IN THE DRAWINGS

TITLE: PORT-BASED PACKET FILTER
INVENTORS NAME: Charles L. Brabec
SERIAL NO.: 09/746,205

Fig. 3

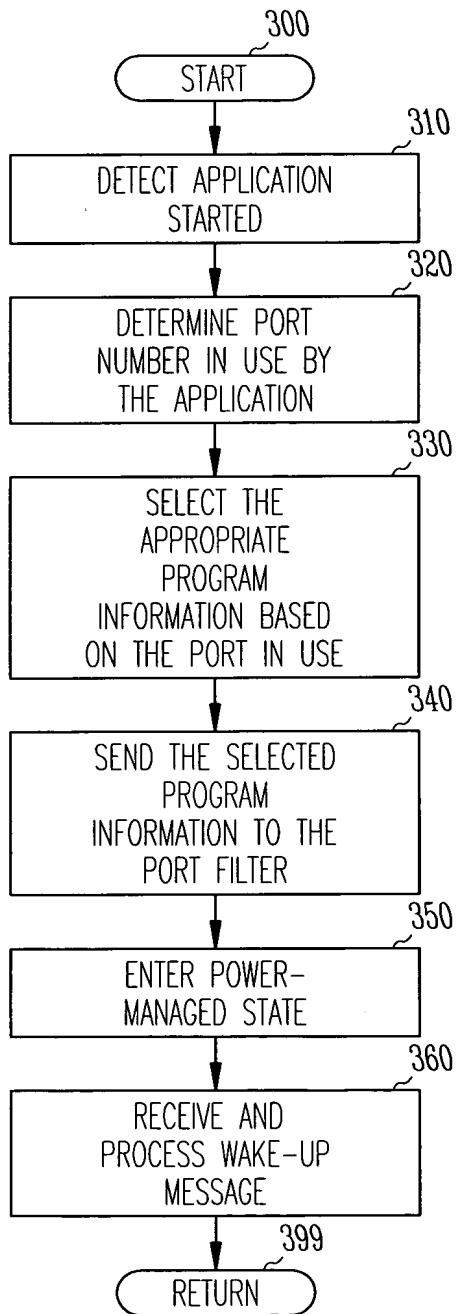
The drawings have been objected to because "port identifier" as per claims 1, 12, and 23 are allegedly not shown in the drawings. Claims 12, 18, 22-24, and 28 have been amended to recite a "port number." Applicant does not concede that 'port identifier' is not shown in the drawings; however, to facilitate prosecution, the above-mentioned claims have been amended. Further, block 320 in Fig. 3 has been amended to "DETERMINE PORT NUMBER IN USE BY THE APPLICATION."
